Re: GMC - Saginaw Nodular Iron MID 0141 793 340  
Closure Plans for the Old and Existing Calcium  
Carbide Desulfurization Slag Treatment Units

**CLOSURE PLAN AMENDMENTS  
FOR  
CALCIUM CARBIDE DESULFURIZATION SLAG  
EXISTING BUNKER AND OLD PAD**

**AMENDMENTS TO THE CLOSURE PLAN  
FOR THE EXISTING CALCIUM CARBIDE  
DESULFURIZATION SLAG TREATMENT BUNKER**

Amendments to the "Interim Status Closure Plan for Existing Calcium Carbide Desulfurization Slag Treatment Bunker, Saginaw Nodular Iron Casting Plant, December 21, 1987."

Page 17, Figure 2.

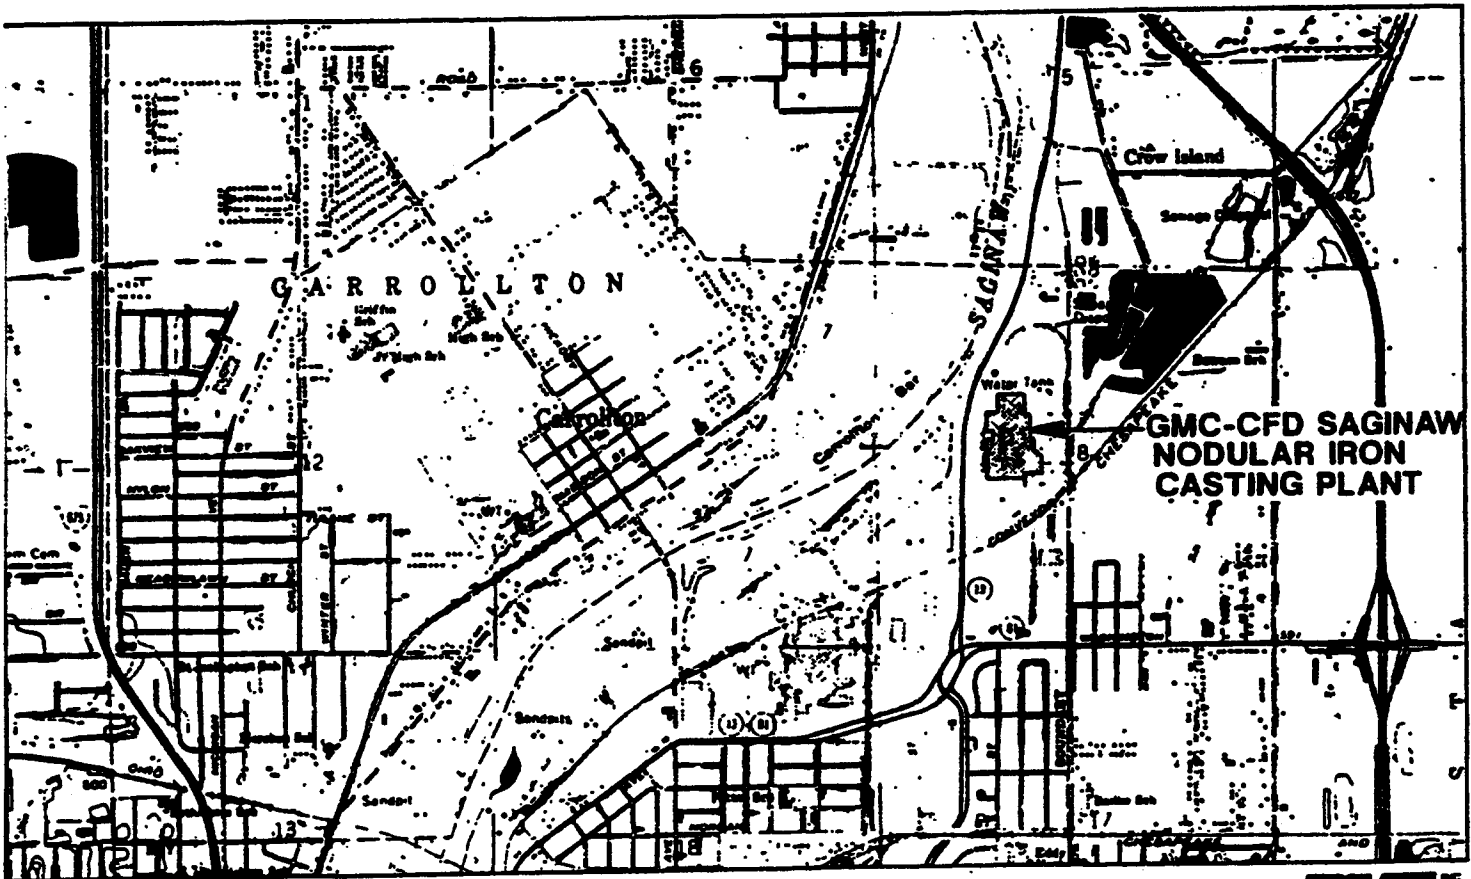
Inasmuch as the closure plans are intended to address the treatment units rather than extended portions of the facility, the sampling grid shown in Figure 2 of each plan is unnecessarily broad and, in the case of the grid for the old treatment unit, inadequate. The grid for the old treatment unit currently specifies 25 boring locations on a square grid of 100 feet by 100 feet. However, there is only one boring location within the 20 feet by 20 feet boundary of the actual treatment unit. SNI believes that three borings (in a triangular configuration) within the boundaries of the old treatment unit is sufficient to satisfy RCRA closure requirements for this unit when considered in conjunction with the soil borings already taken during the preliminary site investigation. The proposed soil boring locations are detailed in the attached closure plan amendments.

Similarly, SNI believes that the four borings that are within the actual boundaries of the Existing Treatment Bunker as specified in Figure 2 of the approved plan is also sufficient when considered in conjunction with the soil borings already taken during the preliminary site investigation of this unit.

Page 16, Section 4.1. Revise the boring identifications to the following:

- . Ten feet west of the west wall of the treatment bunker (Boring 4)
- . Five feet north of the north wall (Boring 3)
- . Thirty-five feet north of the northeast corner (Boring 1)

- Thirty-five feet north and thirty-five feet west of the northwest corner (Boring 2)
- Thirty-five feet west of the southwest corner (Boring 5)
- One hundred ten feet south of the southeast corner (Boring 6)

See the attached, revised version of Figure 2.
